**TOWNSHIP OF NORTH DUMFRIES  
BUILDING DEPARTMENT**

These Plans have been examined for Compliance with the Ontario Building Code requirements. A Building Permit has been Issued, subject to any changes noted, under the condition that the building will be constructed in accordance with the code.

Tice River Homes  
Legacy

client: Tice River Homes  
location: Ayr  
project: Legacy  
marketing name: Legacy

**GROUND FLOOR PLAN  
ELEV. 'A' (LEFT)**

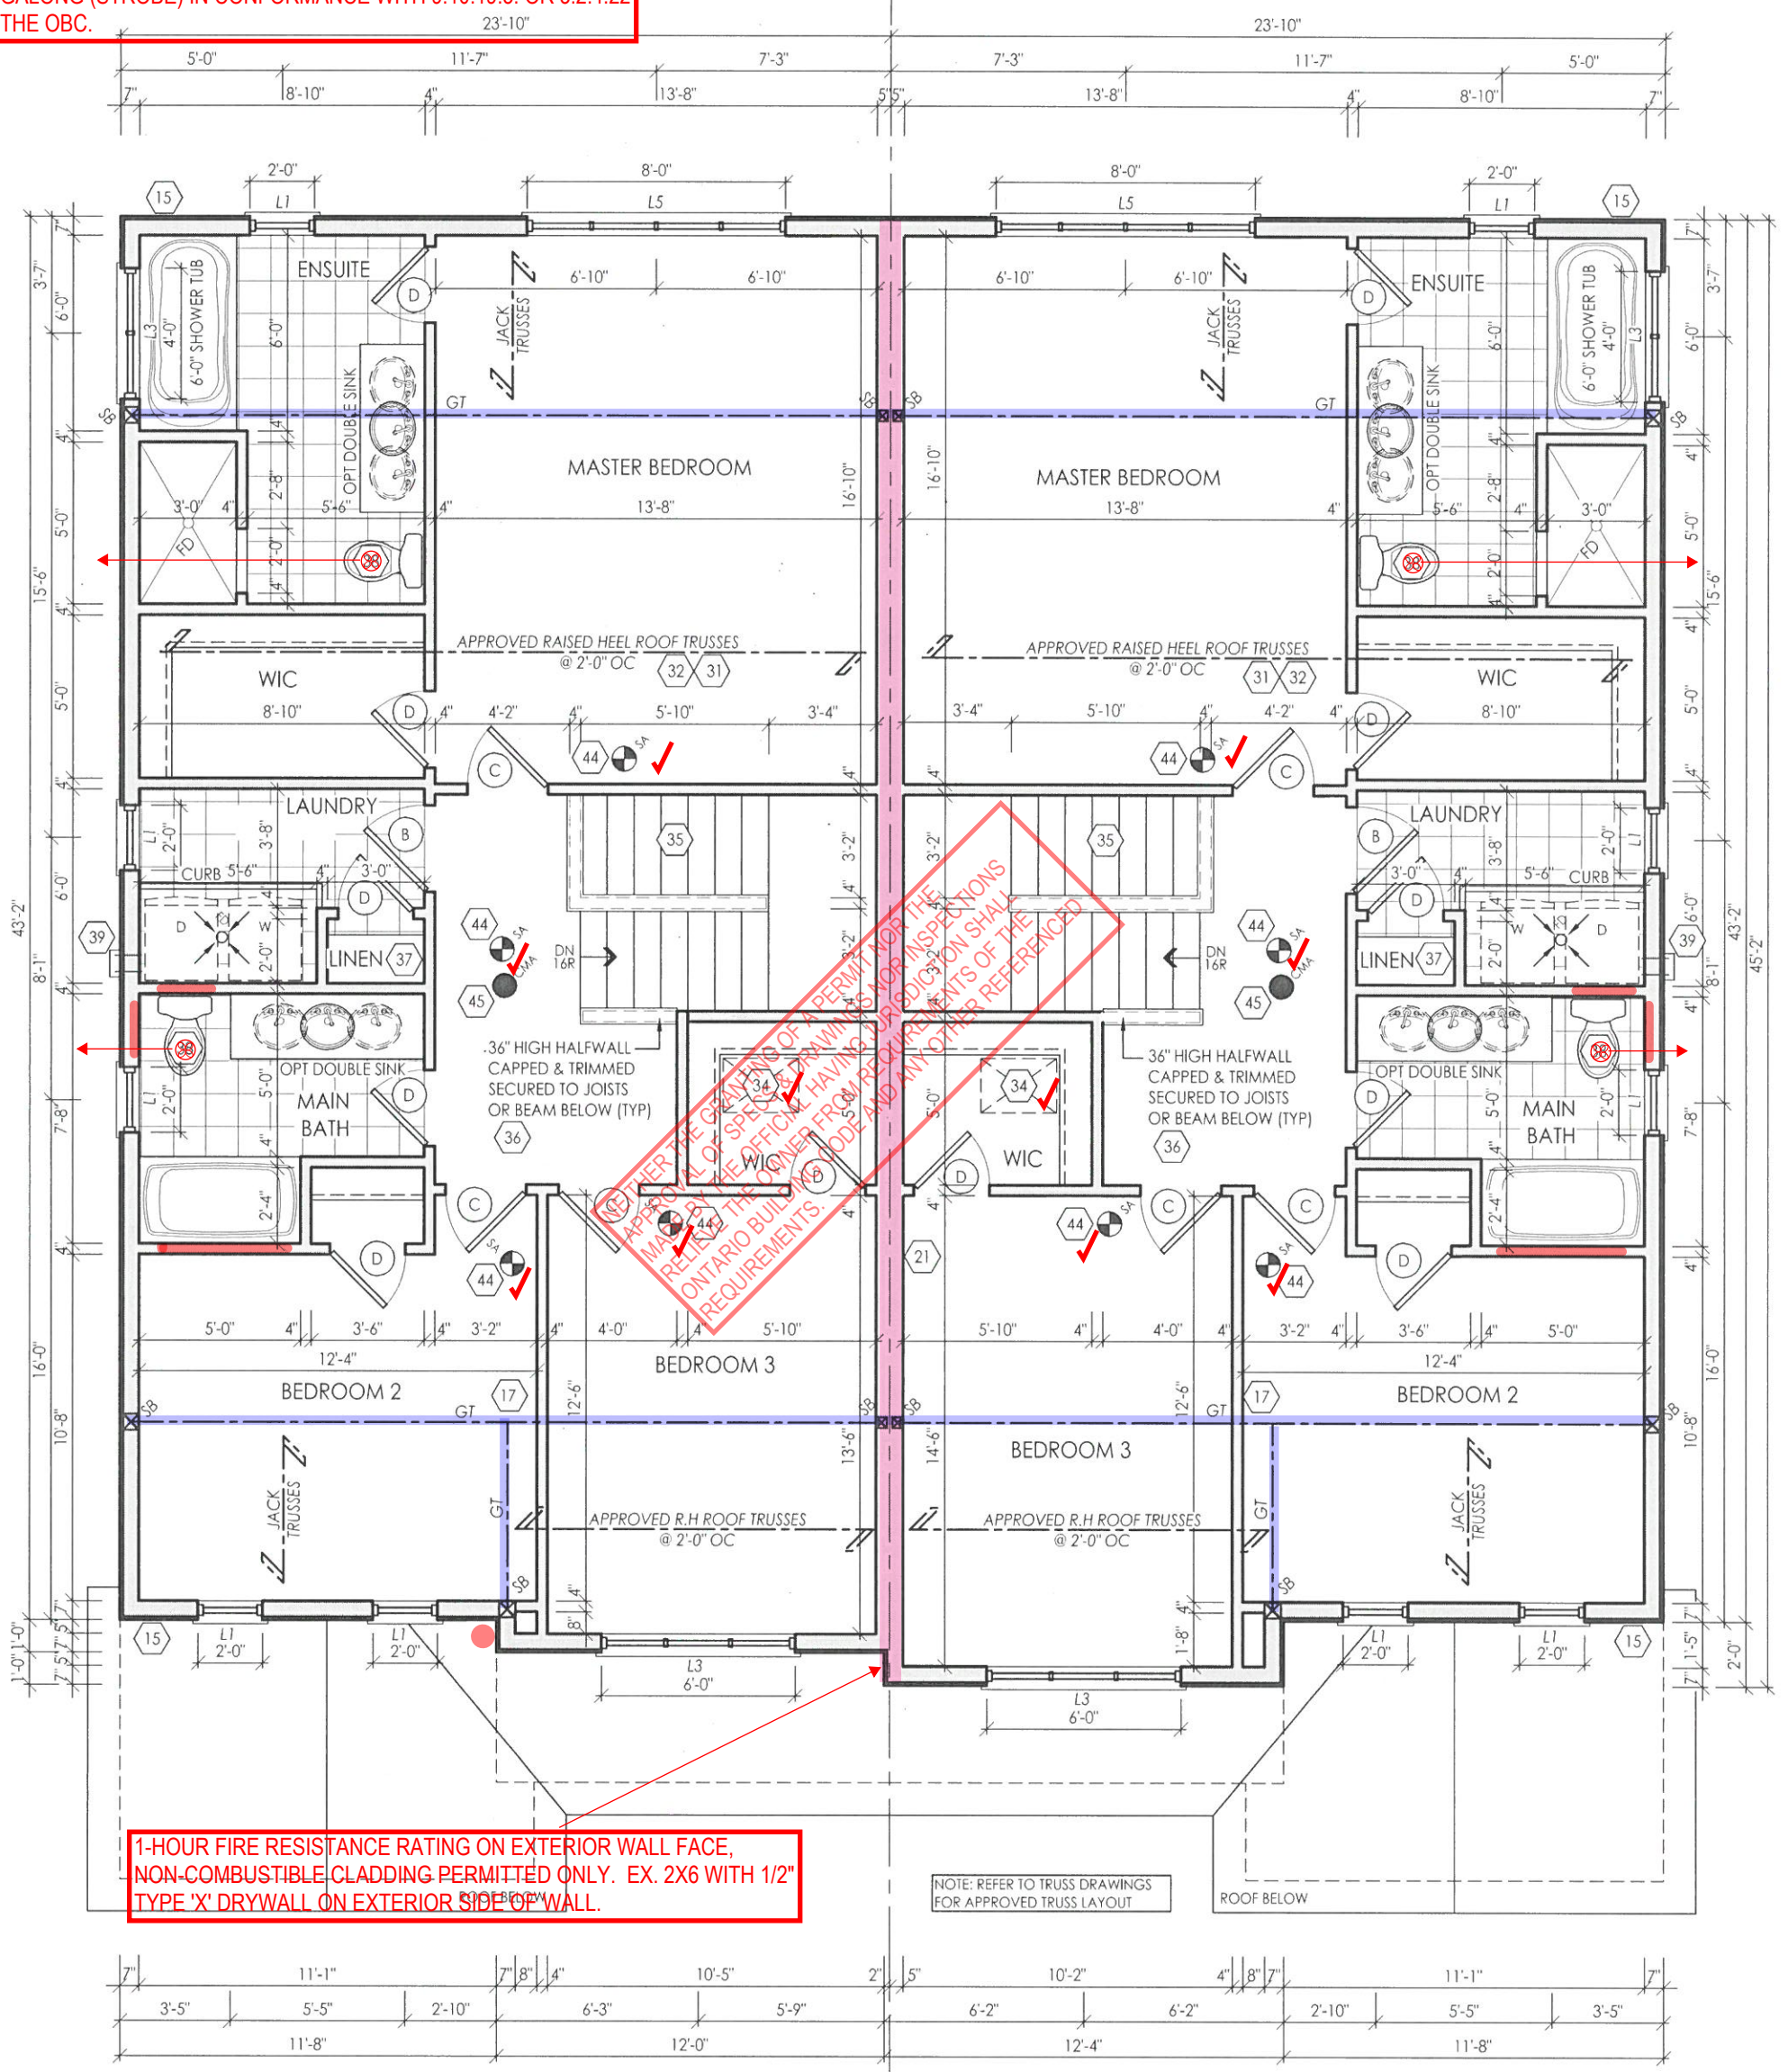
REINFORCEMENT IS REQUIRED FOR THE FUTURE INSTALLATION OF GRAB BARS FOR THE TOILET, SHOWER AND BATHTUB IN THE MAIN BATHROOM AS PER OBC 3.3.4.9.

CARBON MONOXIDE DETECTORS REQUIRED ADJACENT TO BEDROOMS AND MUST BE INTERCONNECTED.

SMOKE DETECTORS MUST BE INTERCONNECTED AND SHALL HAVE SINGALONG (STROBE) IN CONFORMANCE WITH 9.10.19.3. OR 3.2.4.22 OF THE OBC.

1-HOUR FIRE RESISTANCE RATING ON EXTERIOR WALL FACE, NON-COMBUSTIBLE CLADDING PERMITTED ONLY. EX. 2X6 WITH 1/2" TYPE 'X' DRYWALL ON EXTERIOR SIDE OF WALL.

AT LEAST 1 WINDOW SHALL PROVIDE AN UNOBSTRUCTED AREA OF 22" X 39" W/ A SILL HEIGHT MAX. 3'-3" ABOVE FINISHED FLOOR & 23'-0" ABOVE GRADE
